ADDENDUM TO THE CONTRACT DOCUMENTS

ADDENDUM No.: 7

DATE : 9/23/15

PROJECT: New Town Hall
Construction Project
26 Court Street
Plymouth, MA

SKA008

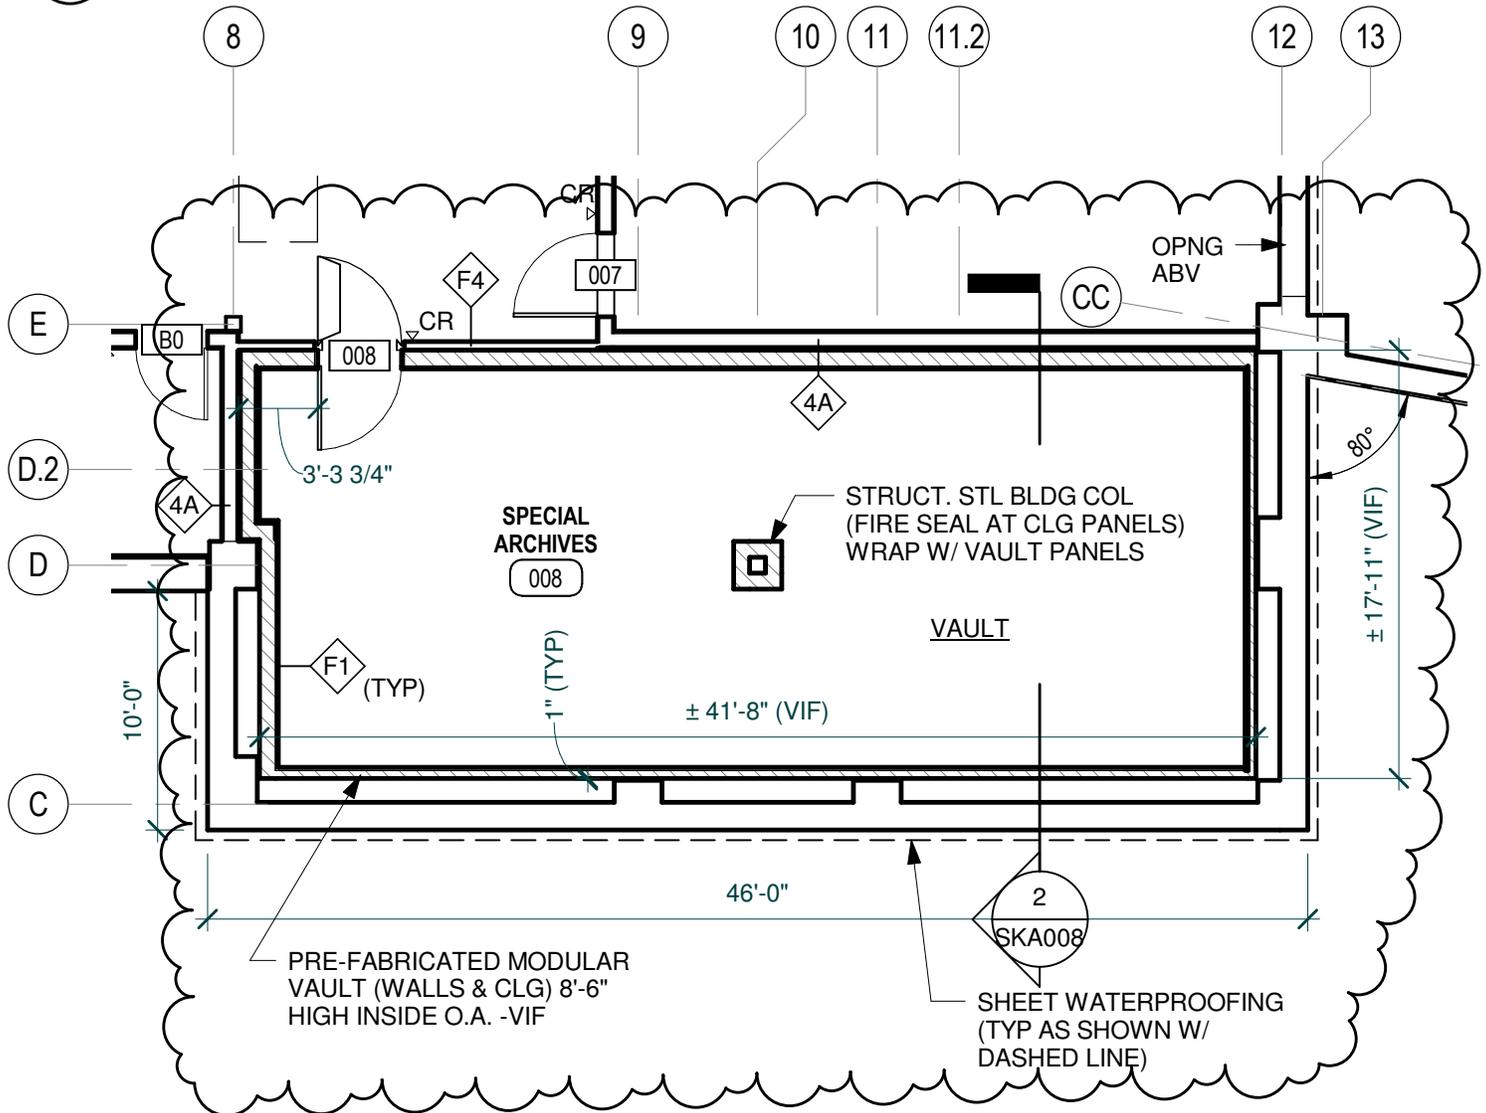
Drawing No.:	Description:
Architectural	
A200	Incorporate the changes to provide a prefabricate vault in the location of Special Archives Room #008 as shown in plan and section on the attached sketch SKA-008 and preliminary manufacturer's drawings. Refer to Section 132700 "Vaults" for additional information. The fire protection, mechanical, and electrical work will be coordinated during construction since the Filed Sub-Bids for these trades have already been received. Provide a furred 5/8" gypsum board ceiling on the ceiling inside the vault.
A402	Section #8 - Revise the zinc shingle note to read as follows: "Zinc shingles on 30 lb. felt over 1/2" thick exterior grade plywood sheathing on galvanized metal framing system over continuous 4" thick mineral wool insulation on typical exterior back-up wall construction."
